Molly McGuire  
Assistant Planner  
Community Planning & Development  
City of Mercer Island  
9611 SE 36th Street  
Mercer Island, WA 98040  
[Molly.McGuire@mercerisland.gov](mailto:Molly.McGuire@mercerisland.gov)

**Comment Letter for Proposed Redevelopment of 6950 SE Maker Street, Permit 2207-019**

Figure 2A: Locations of the contour slices in Figure 2B

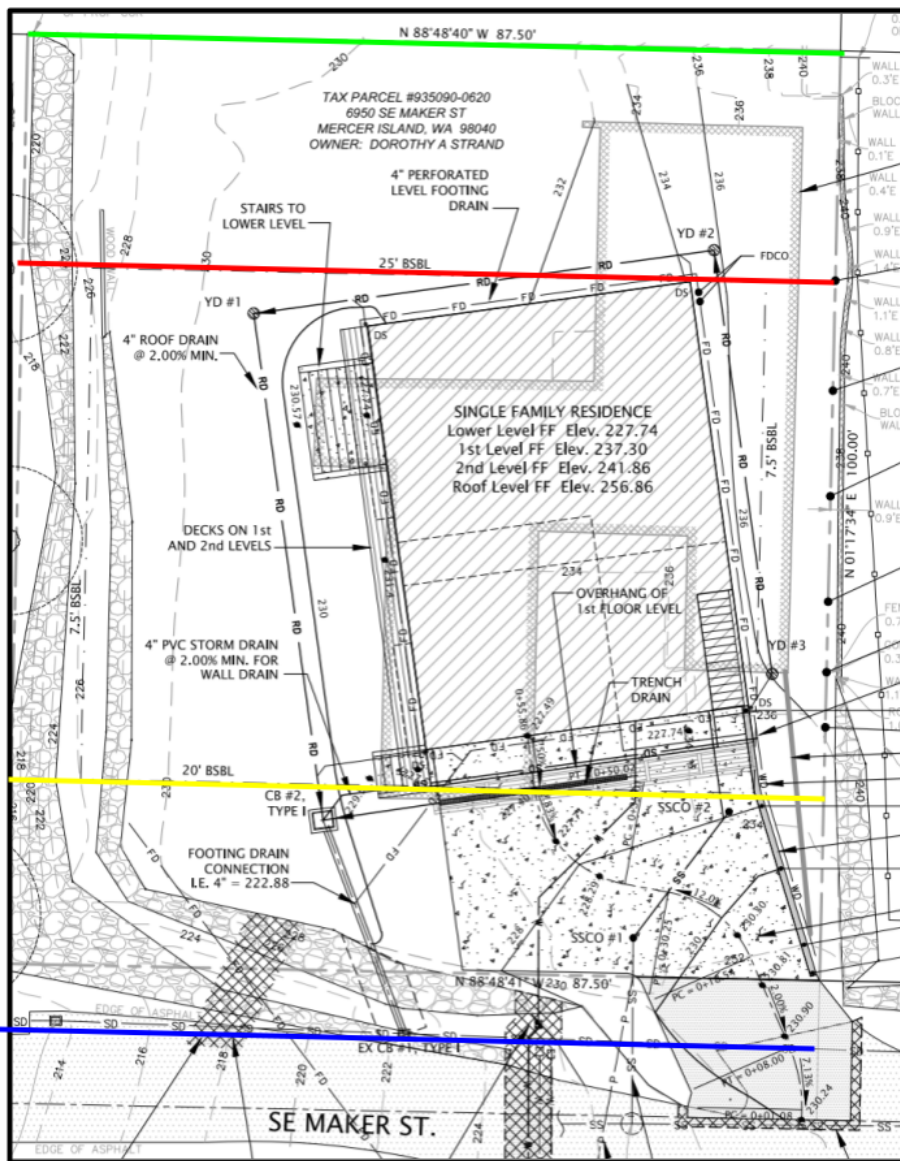
Third, an analysis of cross sections taken through and around The Project shows the degree of artificial elevation. Figure 2A shows 4 east-west cross sections through The Project whose elevation we can measure based on either the known Existing Grade at the lot's boundaries or based on data from The Project's proposal. The colors of each line match the colors in Figure 2B, which shows the elevation as one travels along each line, east to west.

Figure 2B shows that the cross sections corresponding to The Project's building location (in yellow and red) have been significantly artificially elevated (by as much as 10'). The photo in Figure 1 matches the lines in blue (showing the SE Maker Existing Grade) and yellow (showing the proposed Existing Grade on an east-west line 20' from SE Maker) in Figure 2B at 42' from the E property boundary. Please see Dr. Elisabeth Green's comments on the elevation data from a professional geologist's perspective (submitted independently).

Figure 2B: Current Elevations from East Property Boundary to West Boundary

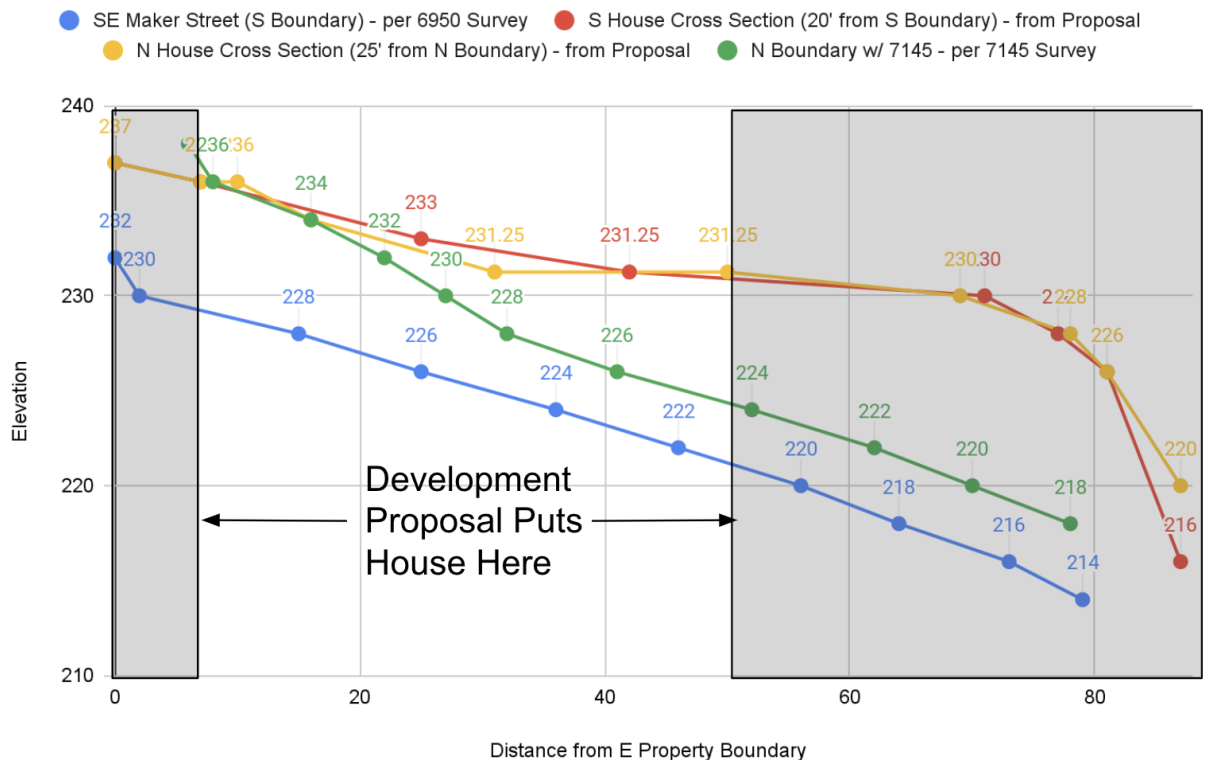
Consequently, the applicant incorrectly computes the Average Building Elevation<sup>2</sup> ("ABE") as 233.06.' My data offers multiple forms of evidence that the correct ABE is approximately 226.7'.

Figure 3: Image from Survey of 7145 SE 35th. 6950 Basement is on the left, North is to the right. Note that the contours go all the way to the house walls of 6950.

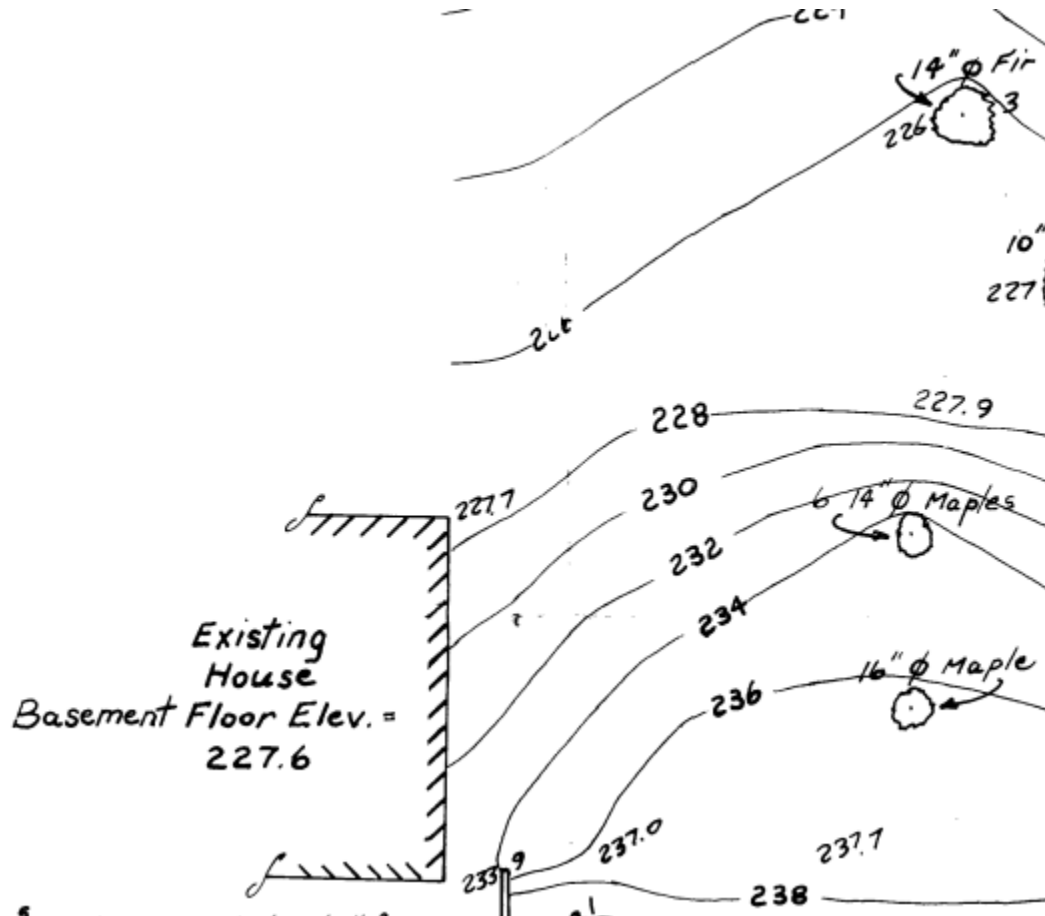
1. **The pre-development survey of 7145 SE 35th Street (the “7145 Survey”)** provides detailed and compelling evidence of the original lot conditions immediately north of the 6950 house. This survey includes the basement of 6950, and the Existing Grade immediately adjacent to the present 6950 house. The survey shows several large trees across the 7145 property, and close to the site of the current 6950 house. These mature trees help to date the topography of 7145 to earlier than the development of 6950 (the photo in Appendix B offers further proof), and offer contour lines for establishing approximate topographic elevations. In addition, the [7145 SE 35th Geotech Study](#) (also carried out in 1989) provides specific insights into three boreholes north of 6950 (see the bottom of page 3 of the geotech study). These boreholes show a natural forest floor with no fill underneath. **In conclusion: triangulating these data points helps establish the correct “approximate topographic elevations” of the north side of 6950.**

2. **The Project's own survey** enables further triangulation of the 7145 Survey data. The 6950 basement's Finished Floor ("FF") is represented in both surveys and provides a common point of reference. The [Project's survey](#) from 2022 (page 2) represents the elevation of 6950 basement's FF at **228.7'**. The 7145 Survey from 1989 lists the FF at **227.6'** (as shown in Figure 3. The fairly small difference in the two elevations can be attributed to changed techniques for measuring elevation in the intervening years). **In conclusion: using the 6950 basement as a common reference point makes it possible to establish the original contours on the north side of 6950 relative to the basement.**

Figure 7: Photographic evidence that the gravel road shown in the 1961 survey was present prior to development of 6950.

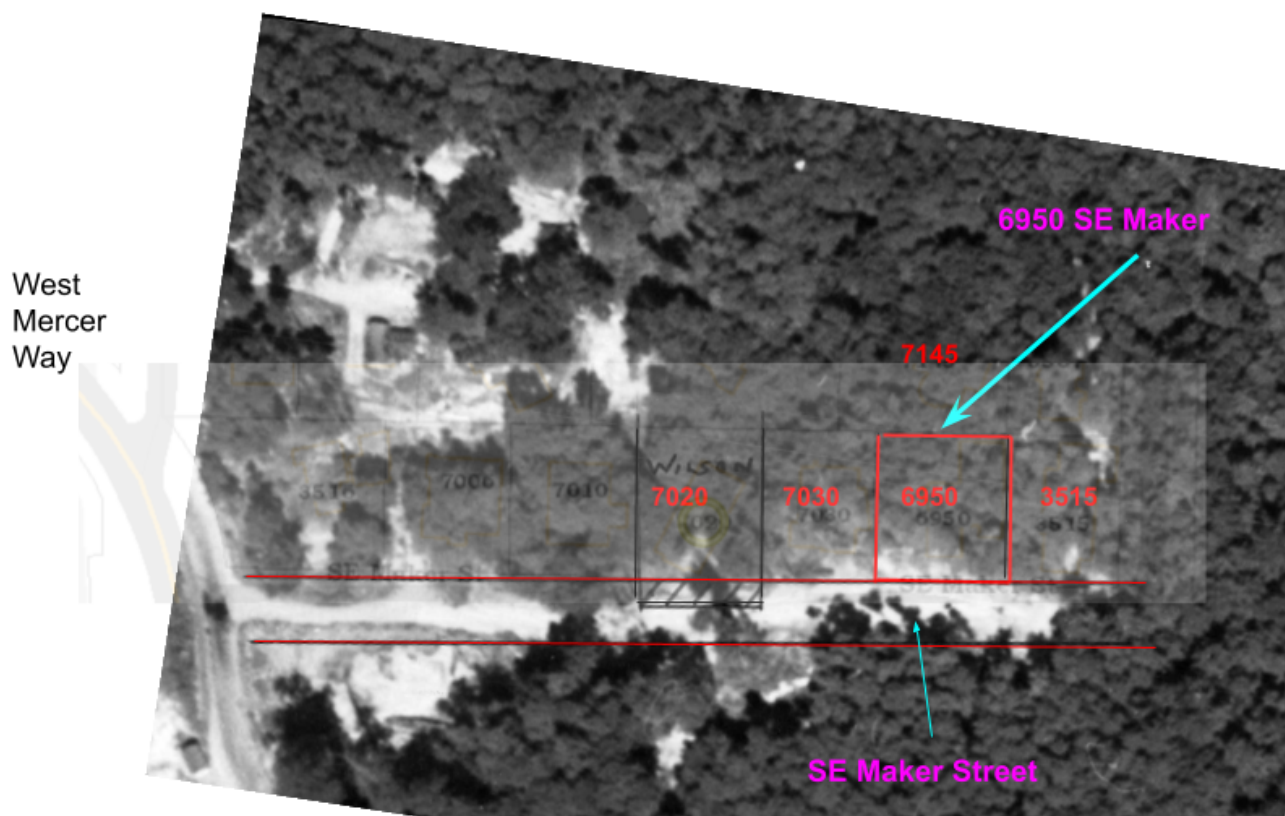
When the boundary lines of the properties from the current GIS are laid onto photo (possible because the 7020 [labeled “Wilson”] property matches 7020’s lot lines today. The West Mercer Way roadway in the photo matches its current GIS data), two things

- The gravel SE Maker Street shown in the 1961 survey was present prior to development of 6950.
- The photo shows the original condition of the lot of 6950, which differs drastically from its condition today.

- SE Maker Street was a gravel road that was first paved no earlier than 1963, according to Mercer Island Public Works. Figure 7 shows this road.
